Ref: 0947r02v02

**RE: 5 LAUDERDALE AVENUE, FAIRLIGHT (DA 2024/1562)  
LETTER OF RESPONSE TO COUNCIL**

Council issued an Engineering Referral Response (Council Letter) dated 20 November 2024 relating to the proposed vehicle access of the development. In this regard, we confirm that we have taken Council's comments into consideration, amended the Ground Floor Plan accordingly, provided as **Attachment 1**, and provide the below commentary in response to the Council Letter.

**1 LEVEL 1**  
1:100

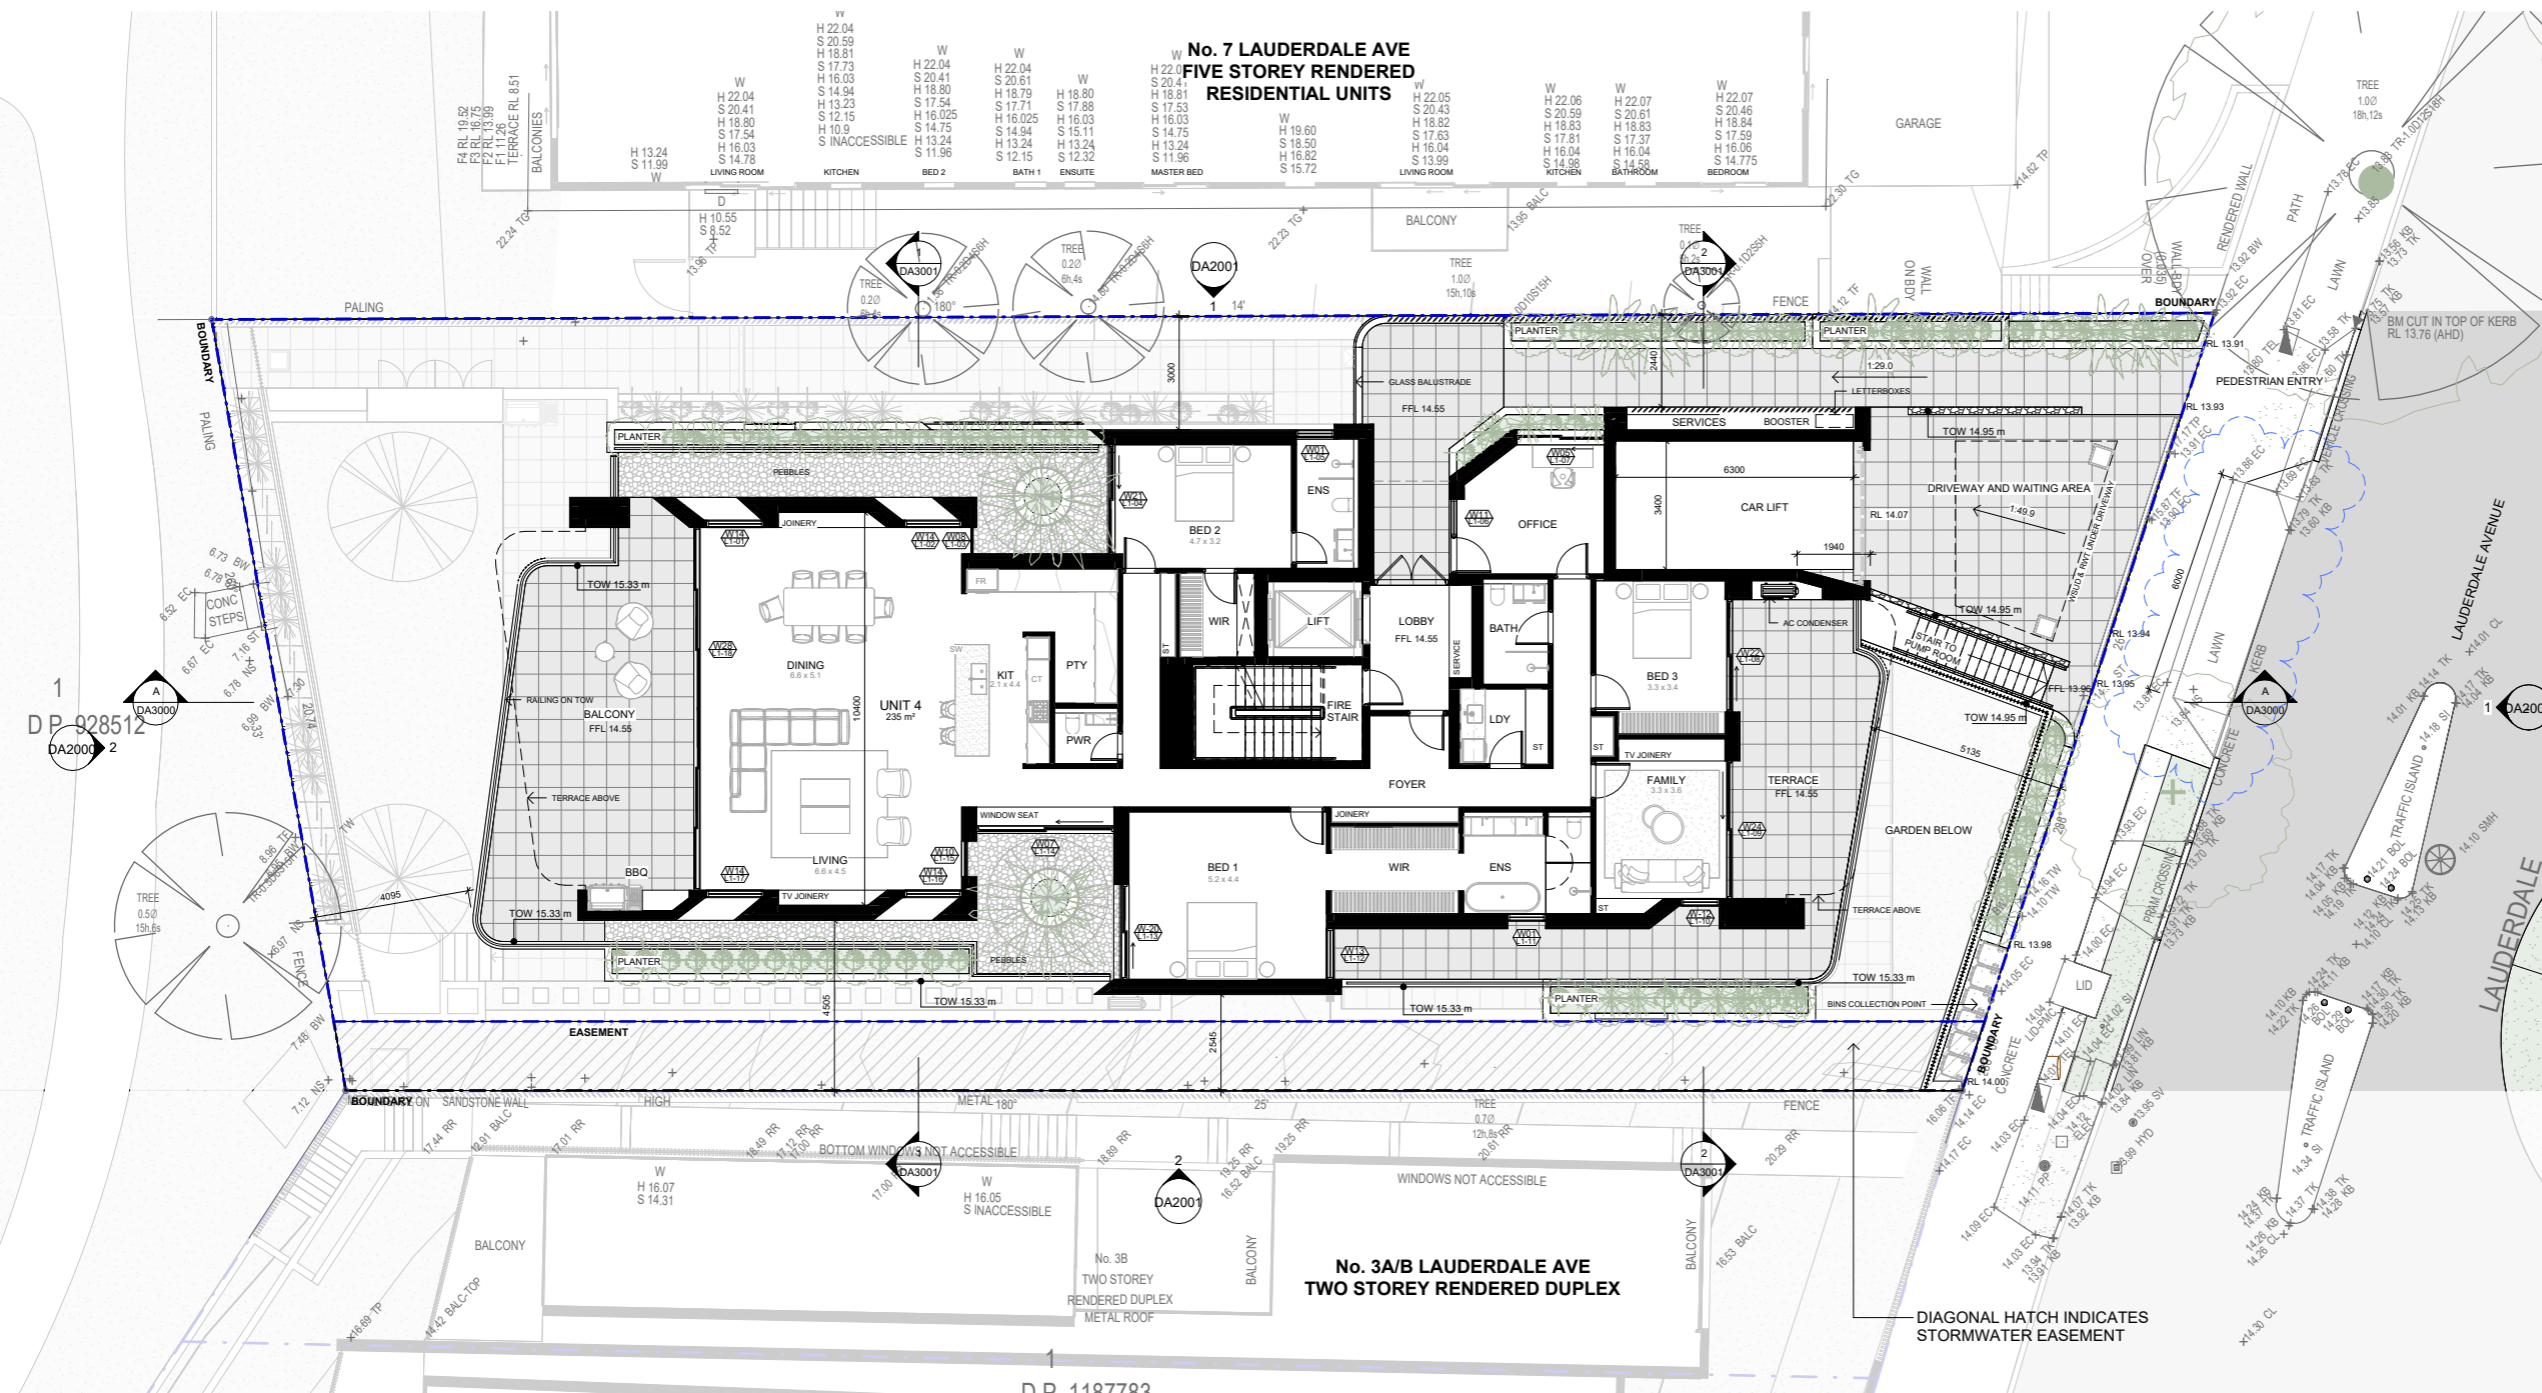
*The proposed vehicle crossing width of 7 metres is not supported. A maximum width of 4 metres is recommended and 6 metres will be accepted subject to justification by applicant.*

The recommended width of 4.0 metres as per Council's Letter is not sufficient to meet the requirements of the development. As such, the width of the vehicle crossing has been reduced from 7.0 metres to 6.0 metres. The provision of two-way vehicular crossings is very common for a host of intuitive reasons. As requested, justification for the 6.0 metre vehicle crossing width is provided herein.

While this is thought to be a very low probability event, it is considered important to provide a passing bay at street level wholly within the property boundary. This would allow one inbound vehicle to stand within the site whilst waiting for the second vehicle to depart using the car lift. For such a passing bay to be operational, the vehicle access over the Council verge must be 6.0 metres.
